STAFF REPORT
COMMUNITY DEVELOPMENT DEPARTMENT

SUBJECT: FP-2022-0005
Graycliff Estates No. 2

Final plat consisting of 54 buildable lots and 6 common lots on 13.26 acres of land in the R-8 zoning district for the second phase of Graycliff Estates Subdivision.

D. Common Driveway Exhibits

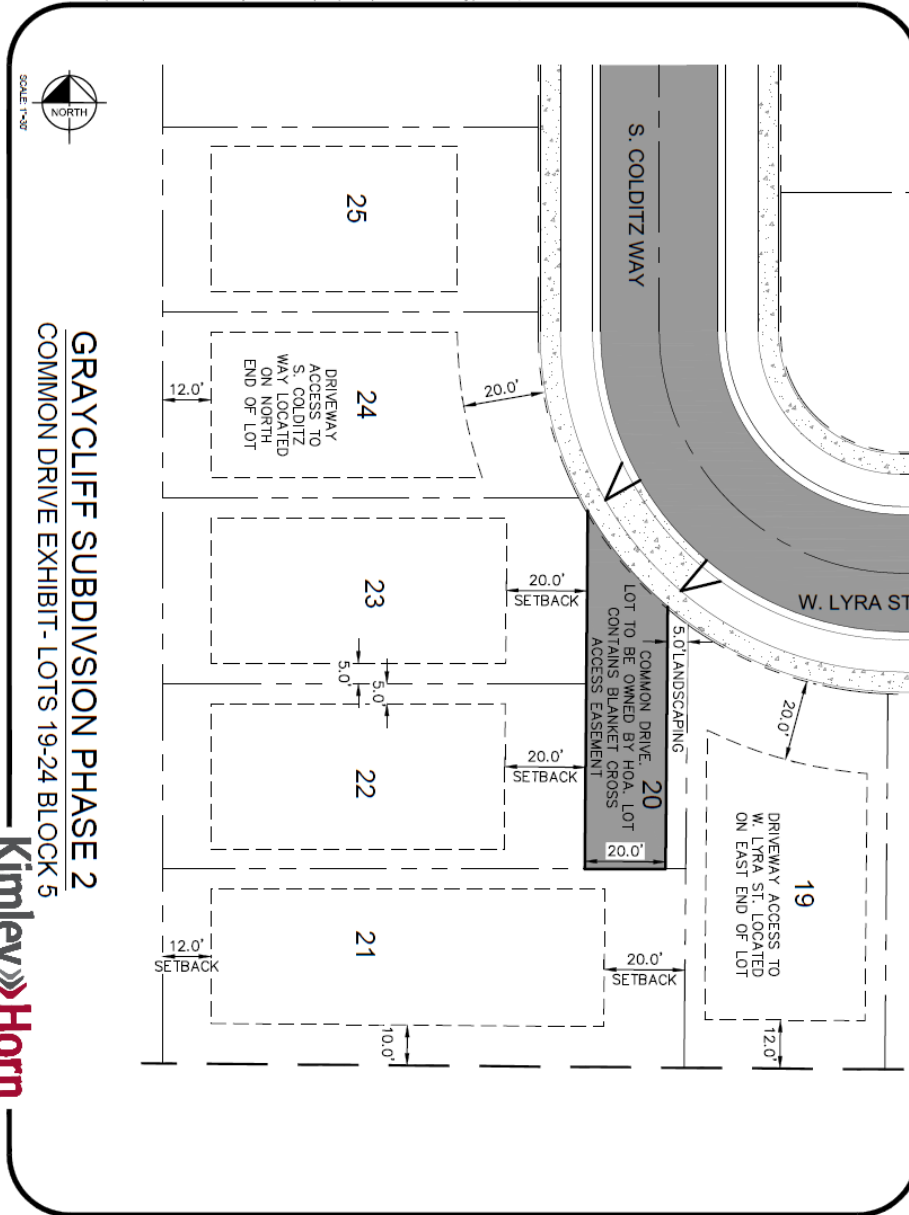
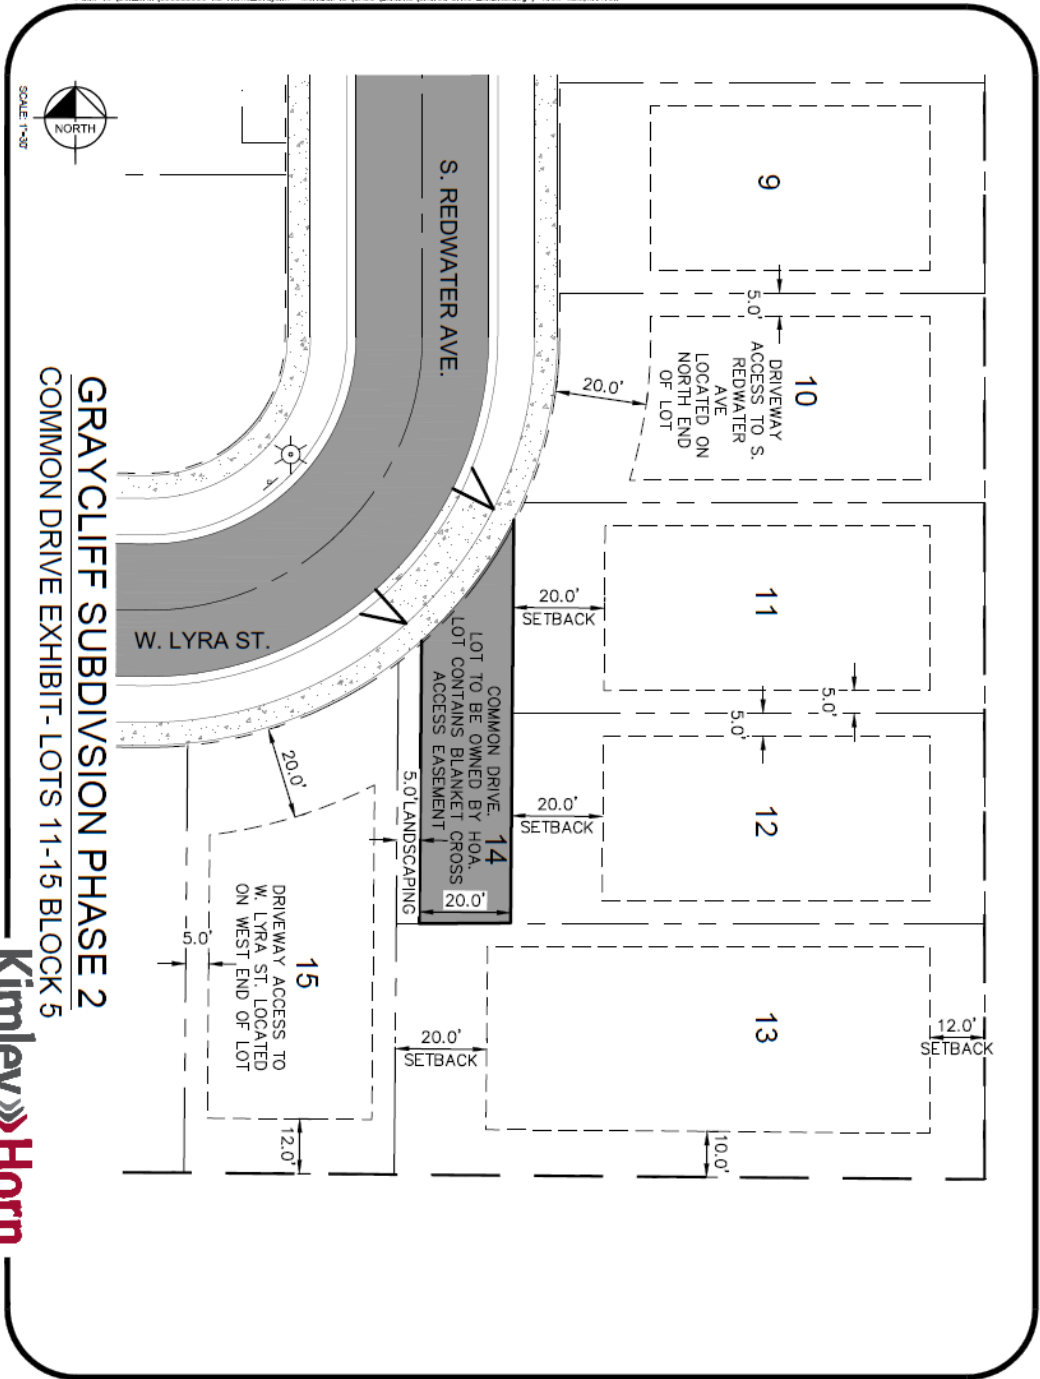
12. Homes on Lots 11-13 and 21-23, Block 5 shall comply with the setbacks depicted on the common driveway exhibits in Section V.D.
13. The well lot (i.e. Lot 1, Block 7) shall be conveyed to the City of Meridian by deed after the plat is recorded, prior to issuance of the first Certificate of Occupancy within the development.
